IMPROVEMENT #7

| CONCEPT PLAN                            |                      |                       |
| SINGER ROAD AT MD 924<br>HARFORD COUNTY |                      |                       |

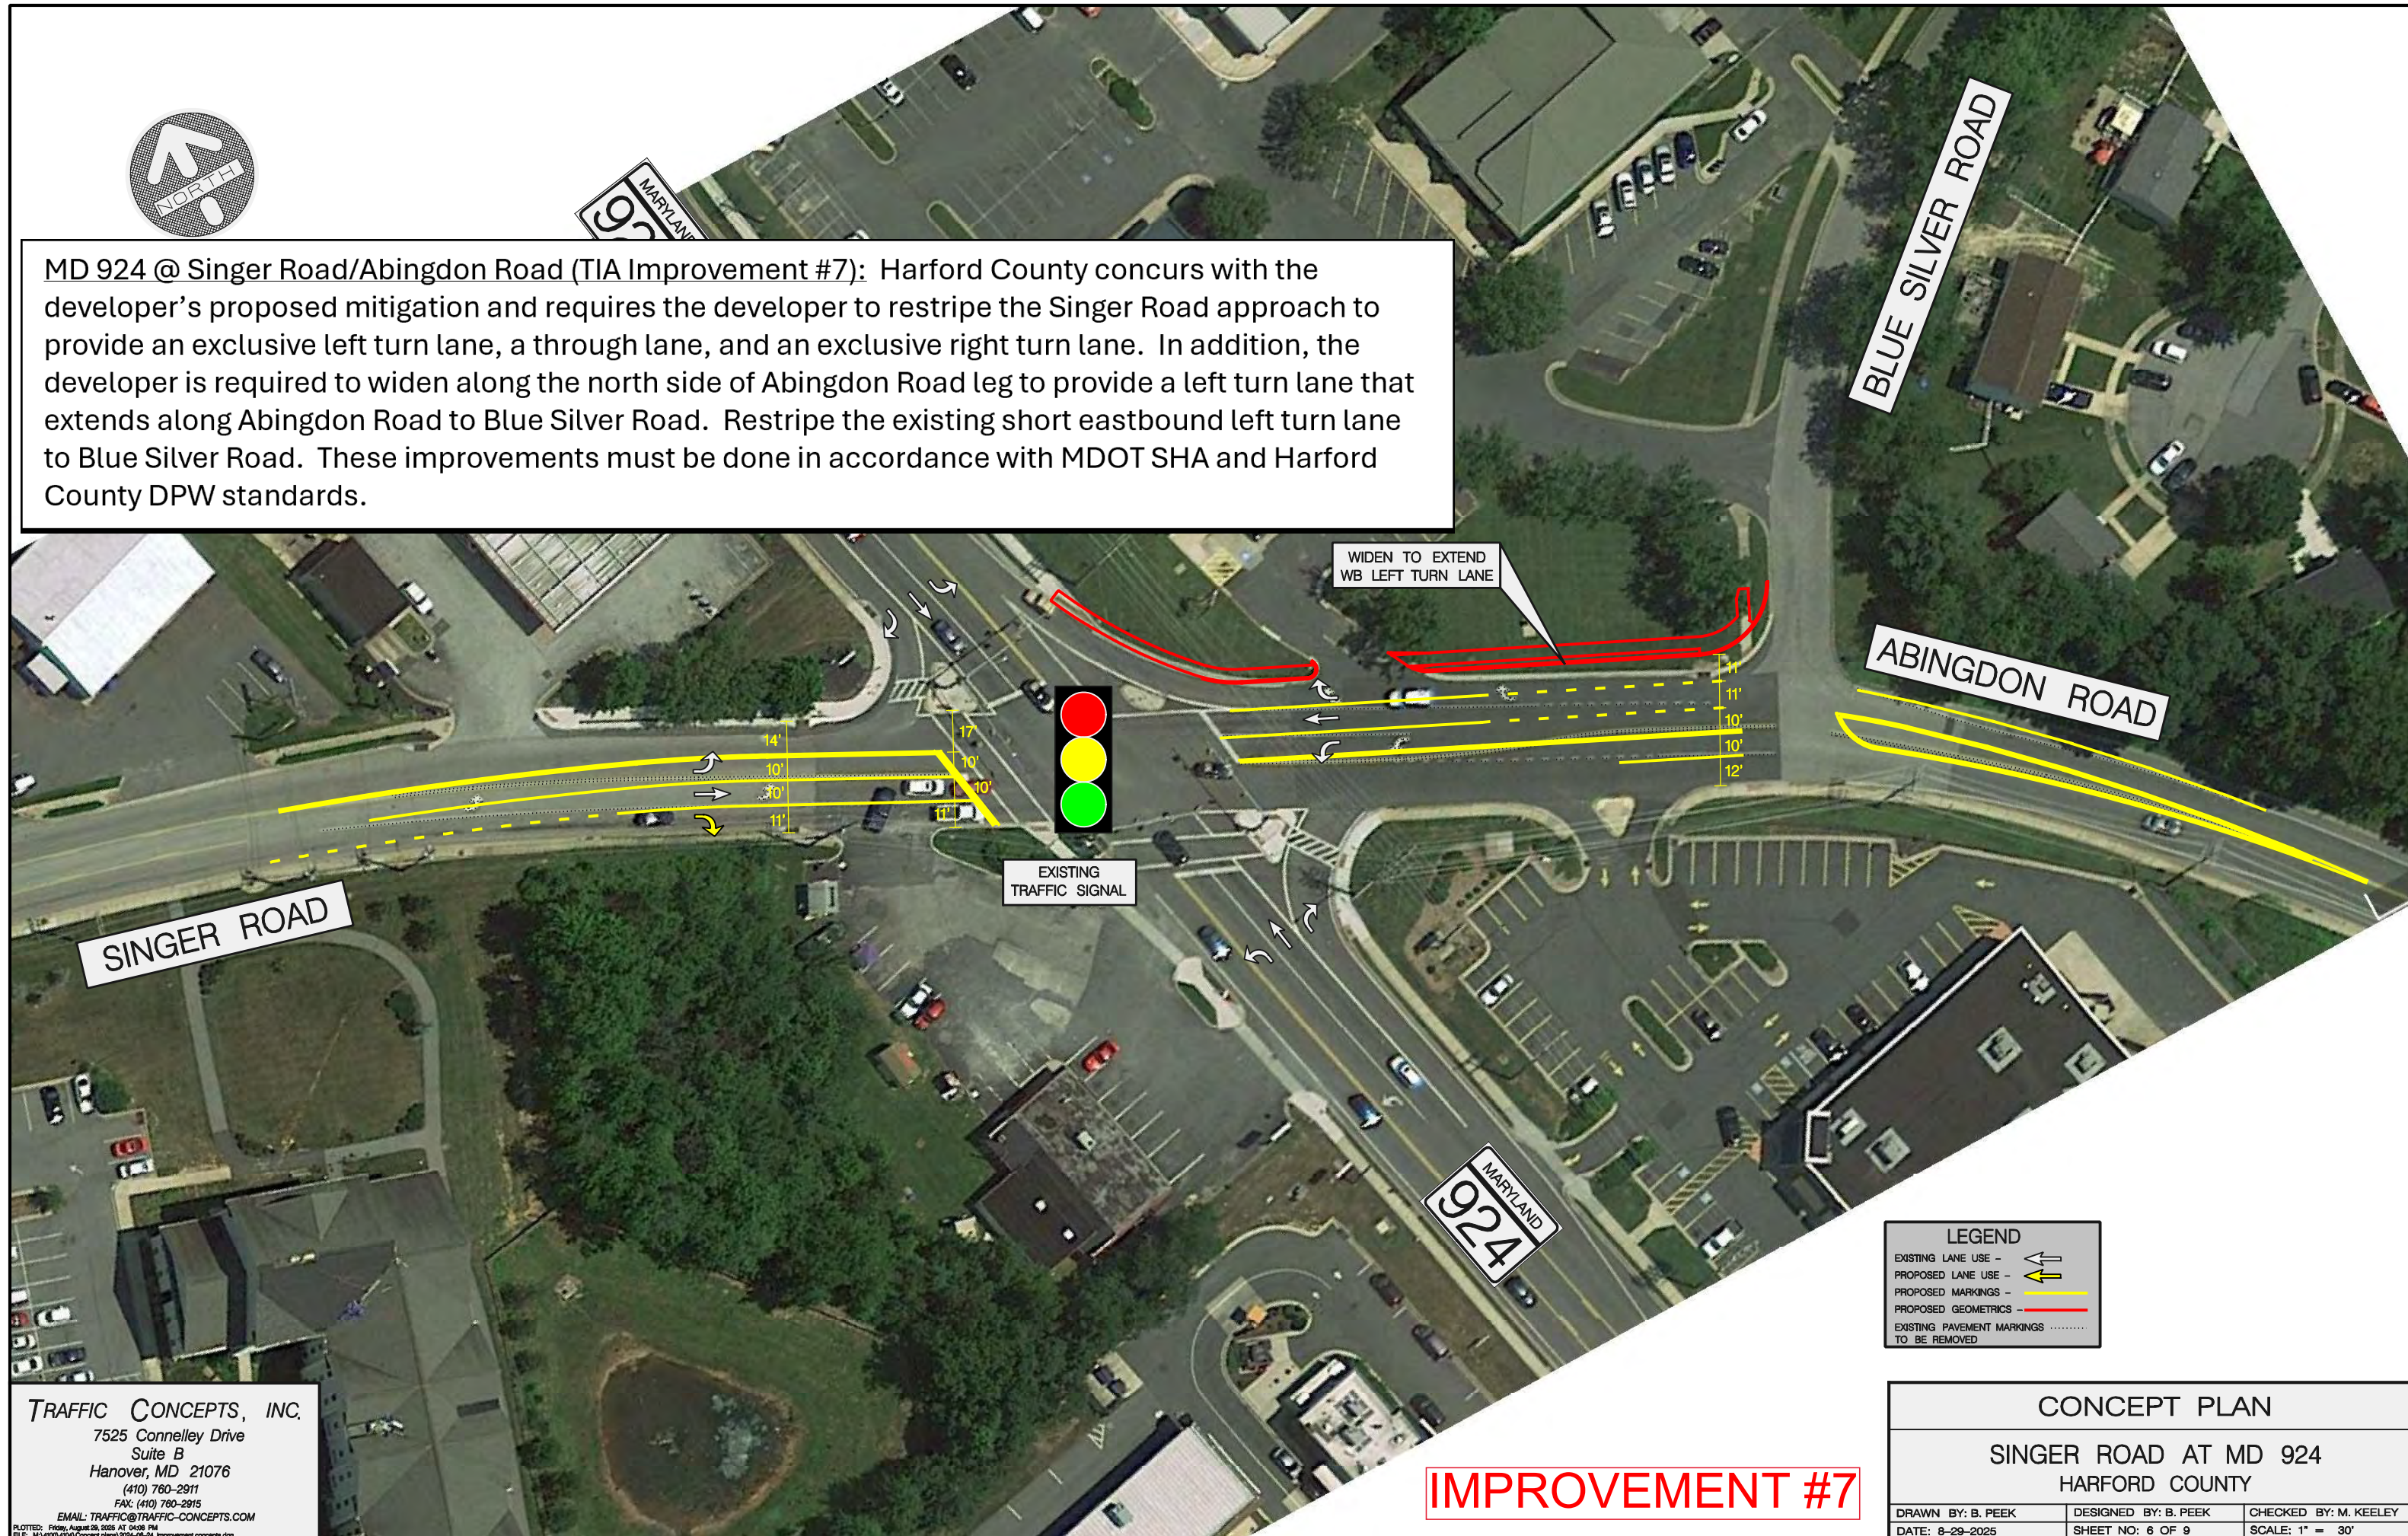
MD 924 @ Singer Road/Abingdon Road (TIA Improvement #7): Harford County concurs with the developer's proposed mitigation and requires the developer to restripe the Singer Road approach to provide an exclusive left turn lane, a through lane, and an exclusive right turn lane. In addition, the developer is required to widen along the north side of Abingdon Road leg to provide a left turn lane that extends along Abingdon Road to Blue Silver Road. Restripe the existing short eastbound left turn lane to Blue Silver Road. These improvements must be done in accordance with MDOT SHA and Harford County DPW standards.
